Service Communication: 2008-002 USA Flag Designation

Subject: Safety Recall Campaign- Norge 1200 accessory top case mounting bracket.

Affected model: Norge 1200 with accessory top case fitted.

New bracket part number: **883147**
(Plastic covering pre-installed)

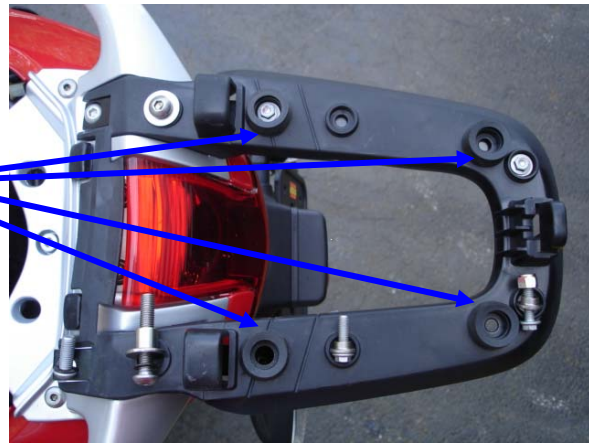
Identification Procedure: Two possible mounting brackets are in circulation.

- 1) Plastic bracket with no latch reinforcement- DEFECTIVE-DO NOT USE
- 2) Plastic bracket with metal latch reinforcement.- O.K. TO USE

DEFECTIVE BRACKET

METAL REINFORCED- O.K.

Parts Information: Brackets that have the metal reinforced latch do not need replacement. Any brackets that do not have the metal reinforced latch will need to be replaced. The new recall bracket has a continuous metal arc support at the rearmost section in addition to an aluminum latch. The plastic covering is pre-installed. Please order this new part through the BM ordering system. Any defective brackets, either from customer bikes or dealer stock, must be returned to Moto Guzzi USA.

- 2) Photo of removed components
Save bolts/screws

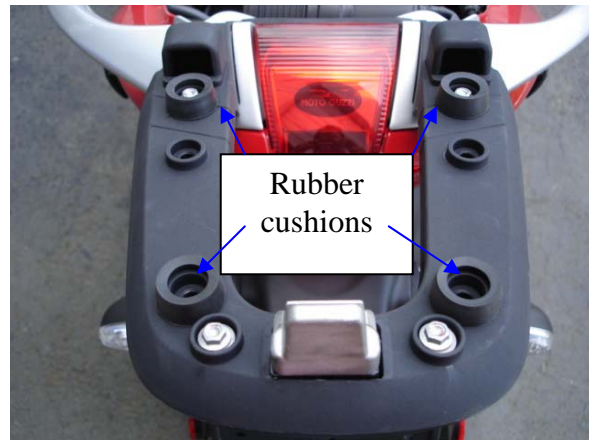
- 1) Remove defective plastic latch with left and right metal supports

Save the 4 rubber cushions

- 3) Fix new bracket 883147- reusing bolts

Torque to 18 ft. lbs.
(Repeat for opposite side)

Torque to 9 ft. lbs.
(Repeat for opposite side)
